LOCAL HISTORIC DISTRICT: Dilworth

PROPERTY ADDRESS: 601 Berkeley Avenue

SUMMARY OF REQUEST: New Construction

APPLICANT/OWNER: John Fryday

601 BERKELEY AVE
PROPOSED SITE PLAN

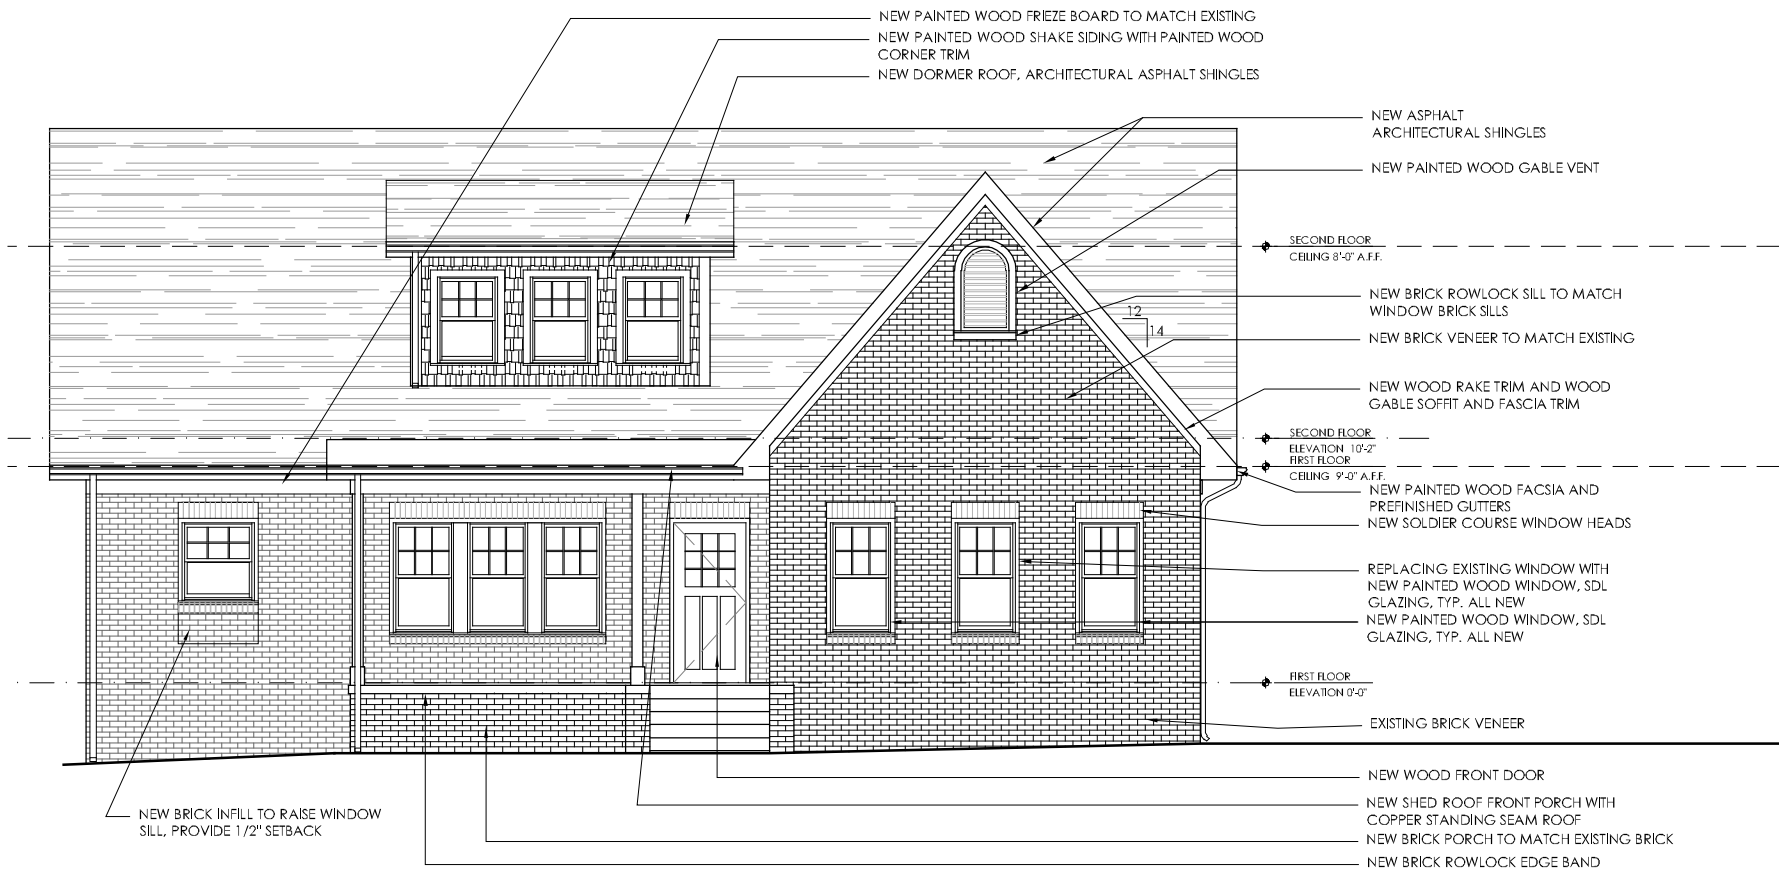
1. Tree save plan for canopy trees on the property (rear yard Oak, front yard trees).
2. Address the coplanar dormers and/or appearance of a two-story house.
3. Indicate height of tallest historic building on the block.
4. Re-arrangement of three cluster windows on first and second story.
5. Provide window trim details for the wood shingle walls.
6. Alternate design detail for the pork chop eave returns.
7. Provide a study of the windows on the right side of the house.
8. Revised deck rail design.

1. Tree protection plan for the 54" oak in the rear yard.
2. Dormer design revised
3. Proposed ridge height is 24'
4. Provided ridge heights of comparable historic heights of houses in the surrounding area.
5. Modified window arrangement on front and right elevations
6. Provided window trim details
7. Changed eave return design

EXPLANATION OF WORK:
THE EXISTING FOOT PRINT OF THE
BUILDING IS TO REMAIN. THE
EXISTING ROOF STRUCTURE IS
BEING REMOVED, A SECOND
STORY AND ROOF BEING BUILT
OVER THE EXISTING FIRST FLOOR,
THEN A NEW ADDITION TO THE
RIGHT REAR PORTION OF THE
HOUSE IS BEING BUILT. NEW
WOOD FRAMED DECK BEING
BUILT. FRAMING IS INTENDED TO
CANTILEVER AS MUCH AS
POSSIBLE TO MINIMIZE THE
IMPACT ON TREE ROOTS

ONE TREE CLOSEST TO THE HOUSE
IN THE FRONT YARD IS BEING
REMOVED. ONE LARGE TREE IN
THE FRONT CLOSEST TO BERKELEY
AND EUCLID IS TO REMAIN. ONE
LARGE TREE IN THE BACK IS TO
REMAIN.

(FEBRUARY) REVISED PROPOSED REAR ELEVATION 01

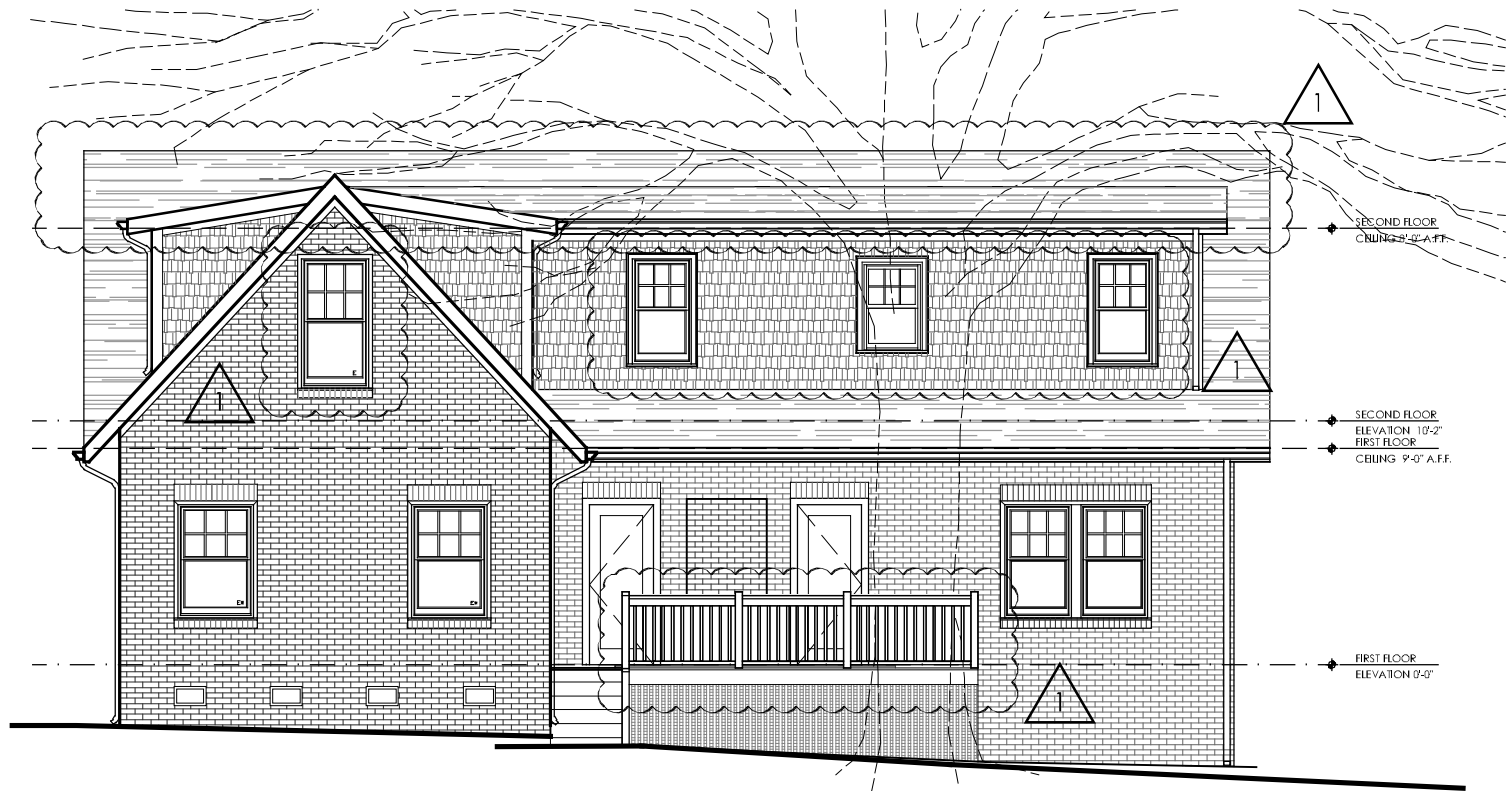
1. Rear porch rail design is not compliant.
2. Minor revisions may be reviewed by staff.
